PARTS & SERVICE NEWS

REF NO.	AA01250		
DATE	Dec. 13, 2001

SUBJECT: REPAIR PROCEDURE OF CAB DOOR

PURPOSE: To introduce modification procedure to prevent breakage of the cab door glass

Process 2: Repair procedure of the door frame by welding
This drawing shows the repair procedure of the LH door frame by welding.
Make repair of the RH door frame in the similar way.

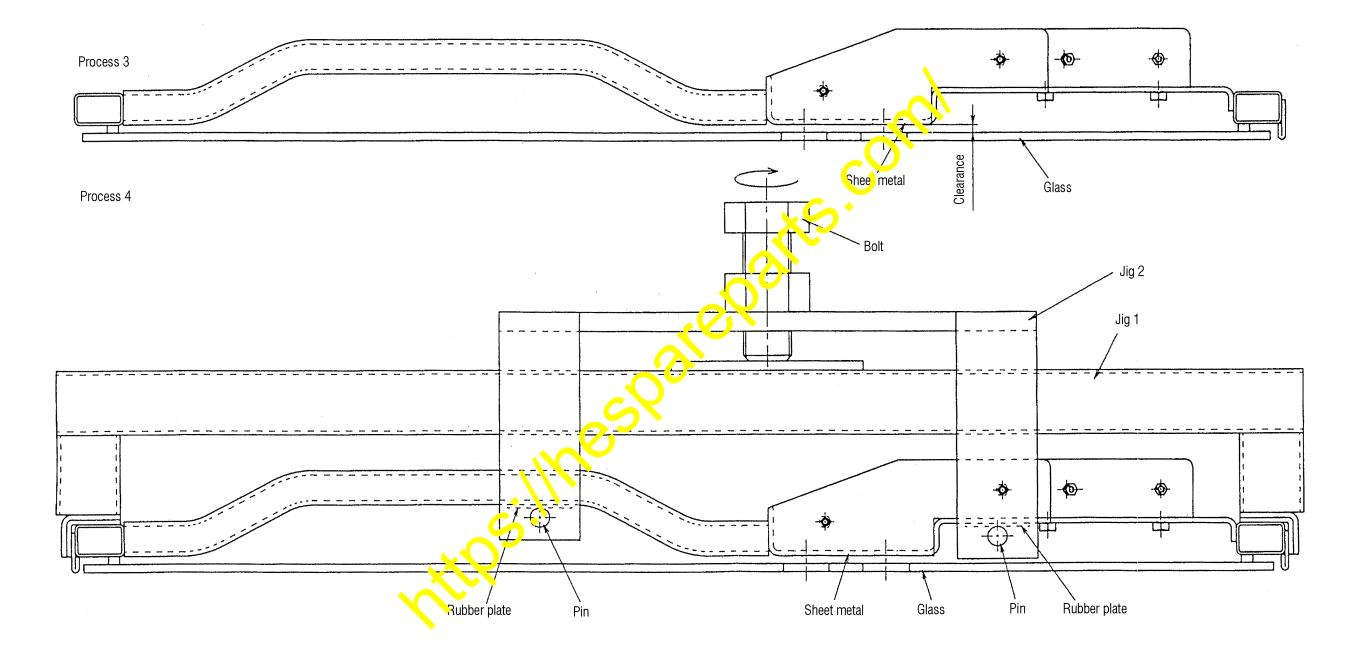
- 3-1. Modification procedure of the door frame (2/3)
- (2) Referring to the Process 2, make repair of the LH and RH door frame by welding.

Photograph of the installed status of the jig to correct the clearance between the glass and the frame (sheet metal)

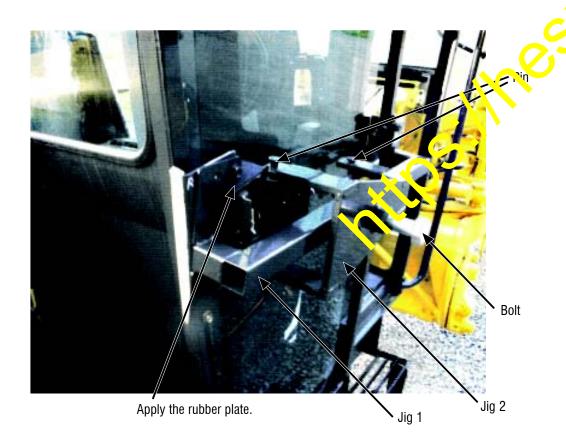
- 3-1. Modification procedure of the door frame (3/3)
 - (3) Referring to the Process 3, check the clearance between the glass and the sheet metal.
 - It is OK if the clearance between the glass and the sheet metal is 5-6 mm.
 - If the clearance between the glass and the sheet metal is less than 5mm, correct the clearance to 5-6 mm referring to the Process 4

- Set the jig 1 and the jig 2 according to the position indicated in the above drawing.
- Turning the bolt clockwise, increase the clearance between the glass and the sheet metal. Standard when increasing the clearance: Increase the clearance by about 6 mm more from the present clearance between the glass and the sheet metal and return the bolt. Then, the final clearance shall increase by about 1 mm.
- (4) Carry out correction painting of the section where the repair by welding was made.

Stopper bolt

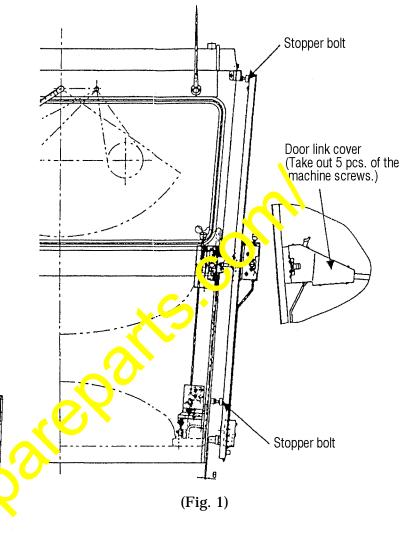
- 3-3. Modification procedure of the stopper bolt
- (1) Disassemble the stopper bolt. (4pcs. on the LH, RH, upper and lower sides)
- (2) Set the door strike section to the lock section of the cab body.
- (3) Confirm if the striker and the lock are concentric. (Refer to Fig. 3.)

After the modification

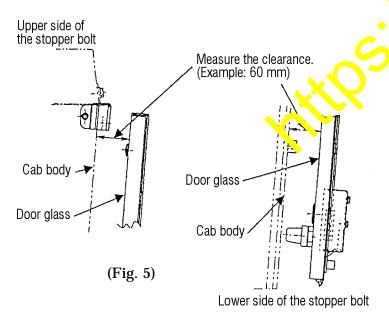
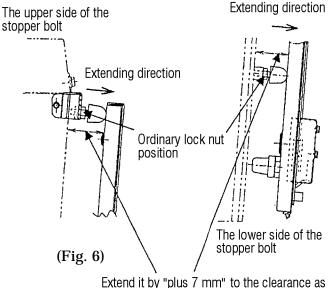
Use this in case it is not possible

to make the adjustment by the

23B-952-2740.

Extend it by "plus 7 mm" to the clearance as indicated in Fig. 5 to set to the position. (Example: The setting dimension is 67 mm.)
